UX30 IO BD R1.1 Change List

UX30 IO BD R1.2 Change List

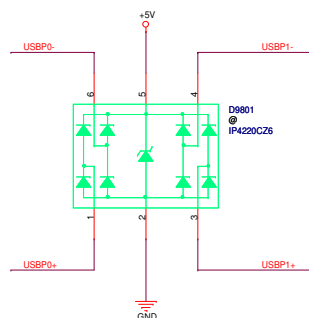
- 1. Remove R9901 and change JACK_SW# to J9901.4 for Headset detect error

- 1. Change J9803 from 12G183402207 to 12G18340200T for cost down on Page 1
- 2. Change J9901 Pin 4 , 5 connection define on Page 2
